DISTRIBUTION CODE MODIFICATION PROPOSAL FORM

Modification Proposal submitted By: Séamus Power	DATE OF SUBMISSION OF PROPOSAL: 30/04/2015	Modification Proposal Number: <i>(to be assigned by Review Panel Secretary)</i> #35
CONTACT DETAILS FOR MODIFICATION PROPOSAL ORIGINATOR: (IF NOT DISTRIBUTION CODE REVIEW PANEL		
NAME: Séamus Power		TELEPHONE NUMBER: 01 2370522
E-MAIL ADDRESS:	seamus.power@eirgrid.com	
MODIFICATION PROPOSAL TITLE:	Power Factor requirements for Type C, D and Type B <5 MW WFPS connections	
DISTRIBUTION CODE SECTION(S) AFFECTED BY PROPOSAL DCC11.4.3 Power Factor		
MODIFICATION PROPOSAL DESCRIPTION <i>(Clearly state the desired amendment and all text changes. Attach further information if necessary)</i> DCC11.4.3 Power Factor <p>WFPSs, with connection types B with a Registered Capacity of <5MW and connection types C and D shall have a settable power factor in the range of 0.92, such that vars are absorbed by the WFPS from the Distribution System, and unity, as measured at the Connection Point. This power factor range is illustrated in Figure 11. The setting shall be specified by the DSO at least 120 business days prior to the WFPS's scheduled operational date. The WF

Figure 11

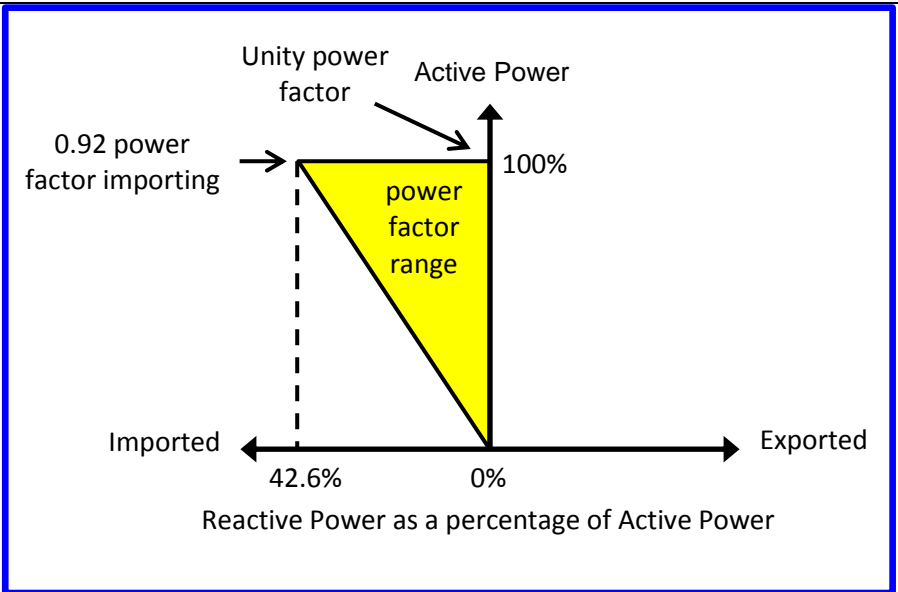
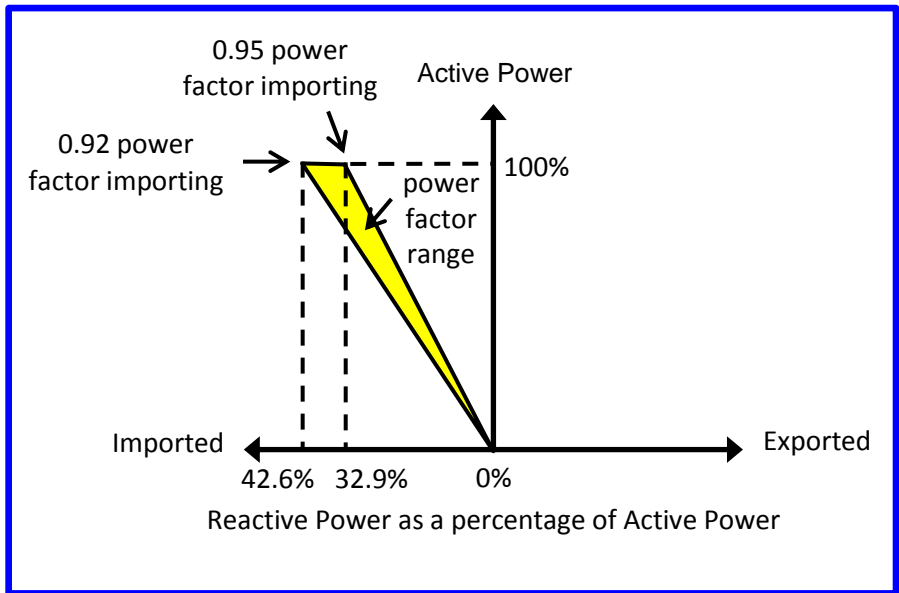
Recent studies completed by EirGrid indicate that there is a significant saving in terms of reactive compensation requirements across the transmission network if Type C- and D-connected WFPSS, whose connection method can support it, can be operated at unity power factor.
